NOvA Response to Questions

June 5, 2007

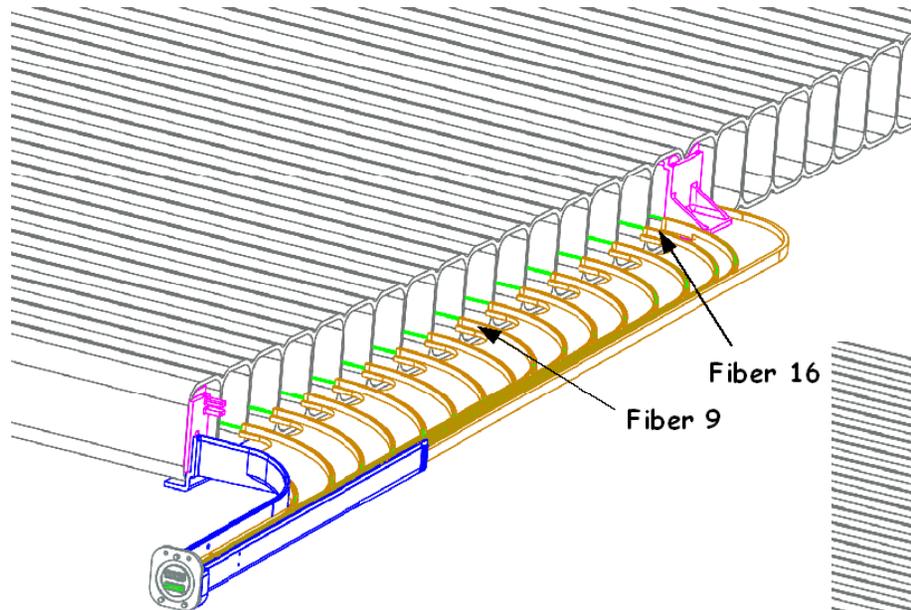
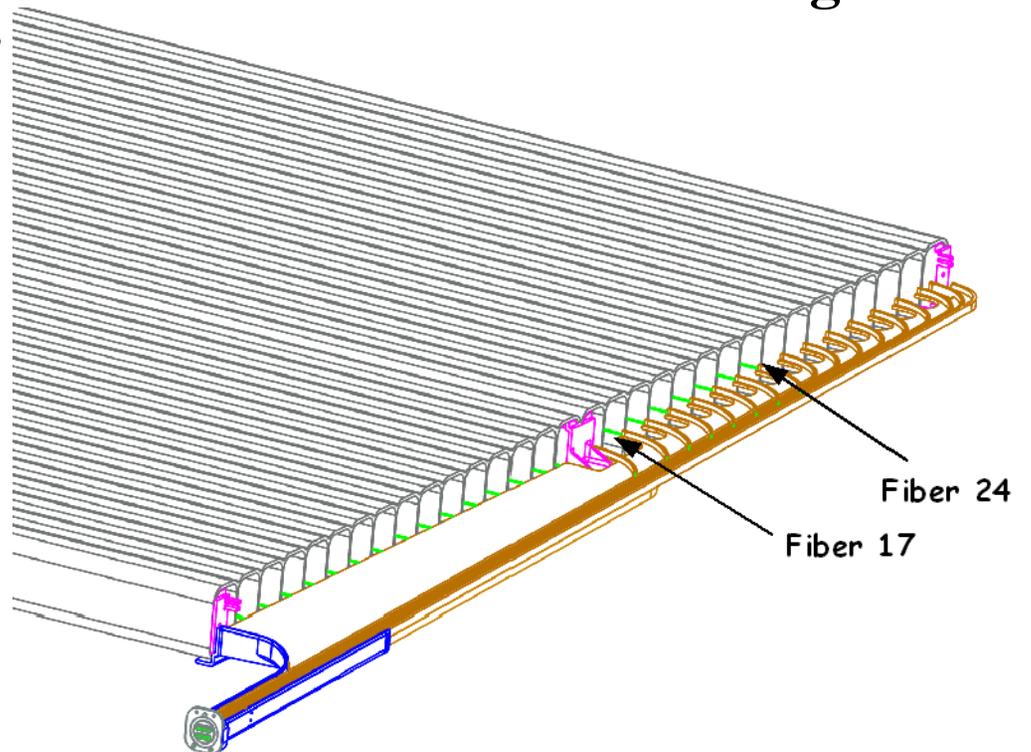
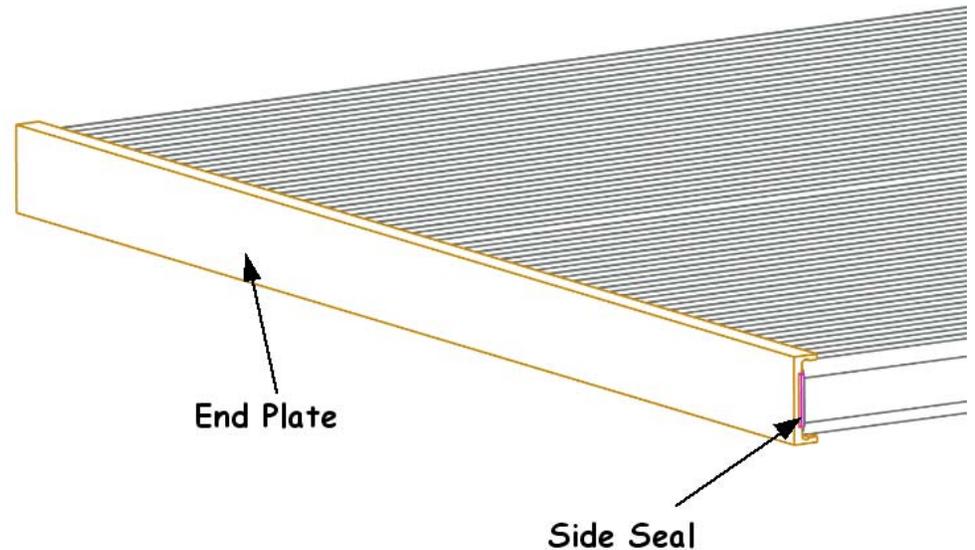
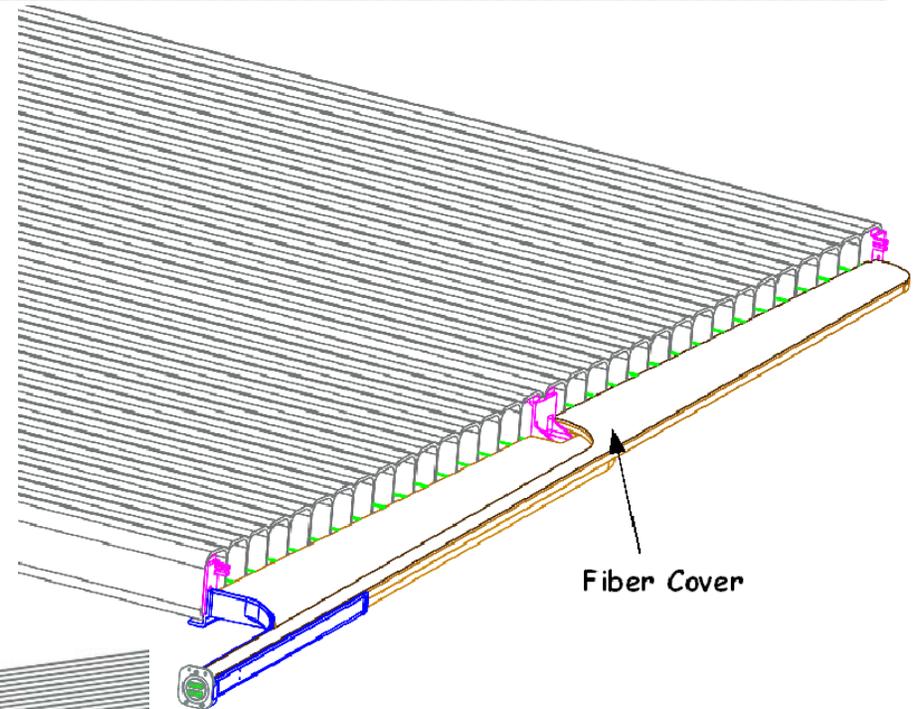
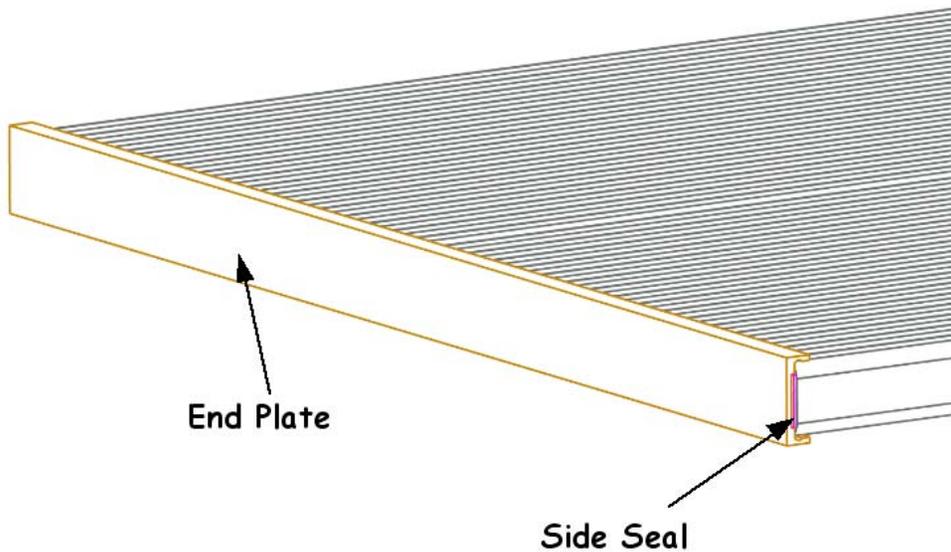
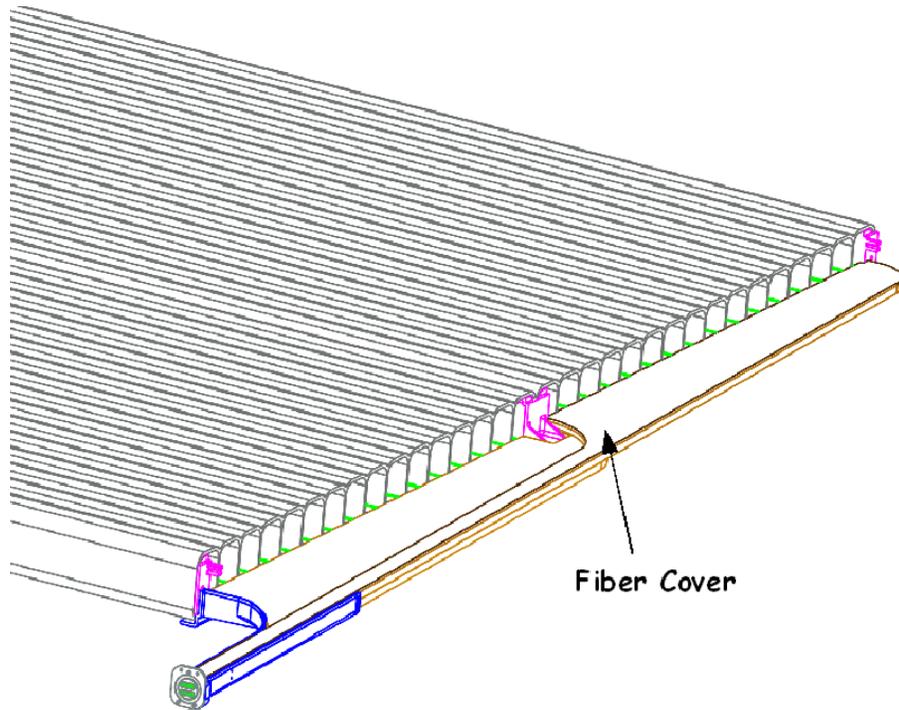
Discuss conceivable interim pressure tests of the integrity of the bottom seal of the PVC Modules before attaching the manifold.

The bottom seal is put on after the fiber is in all the cells.

Bottom is sealed after all the cells are strung and the vacuum fixture is removed.

At the time the bottom is sealed, the top end has most of the manifold already constructed.

To test the seal of the bottom, it is necessary to seal the top. We do this by completing the manifold and sealing it.

One could to build a large fixture that fits over the partially constructed manifold and clamps on the scalloped sides of the extrusion. After waiting overnight for the glue to cure, one could then pressurize the extrusion to test the bottom seal.

- A completely leak tight soft seal on the scalloped surface is difficult.**
- This adds another significant step in the process and increases the assembly cost.**
- If one does detect a leak after testing for 12 hours it is probably the fixture clamp.**

Ratio of base oil price to crude oil. There is not a 1-1 relationship, but rather a distribution. So for a given crude oil price there has historically been a range of base oil prices. This distribution is what we use in our simulation.

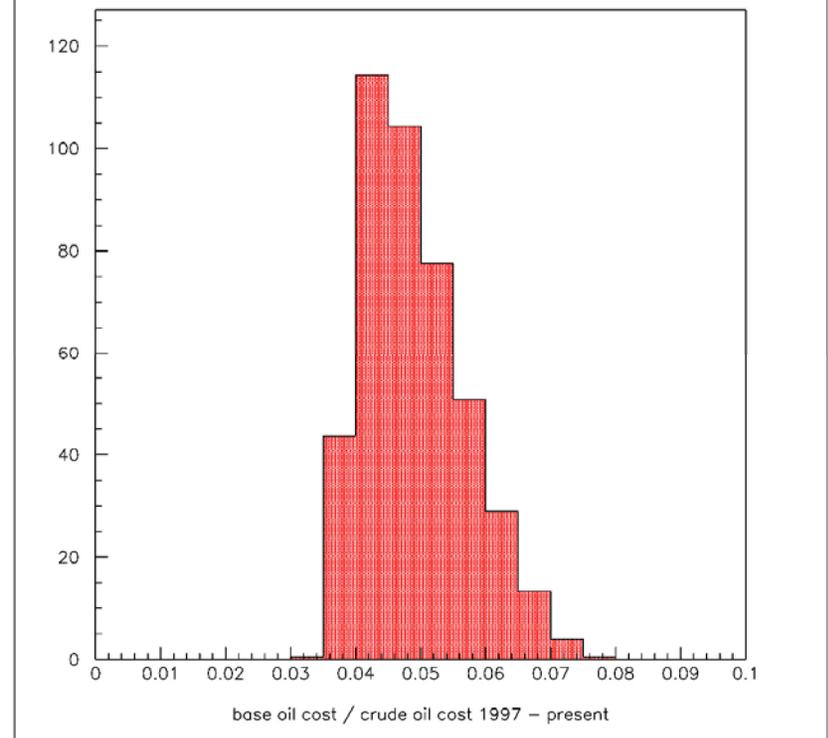
Oil prices aren't based solely on crude prices; rather a combination of crude and the availability of refiners. Note that we actually have crude price per barrel less than or equal to what it was a year ago; however, the price of gasoline per gallon is now a dollar higher (i.e. the price of refining has gone up by 4X). Need to revise your estimates as the gap between the cost of crude correlated to cost of gasoline is still changing. I would assume that you can correlate the cost of gasoline to that of mineral oil as they both come from the same distillation and refinement process.

Gasoline is not relevant. It's connection to crude oil is different than the connection of mineral oil to crude. **We have quotes from suppliers who have indexed the cost of their mineral oil to a specific base oil and we have archival data on the price of this base oil going back ten years. A ten year time span adequately averages over crude oil price movements as well as refinery issues and anything else that might impact the price of mineral oil.** (Refinery issues do occur, they are thoroughly discussed in industry newsletters and we monitor them). We have correlated the cost of the base oil to the price of crude and use this in our model. **SEE NEXT PAGE**
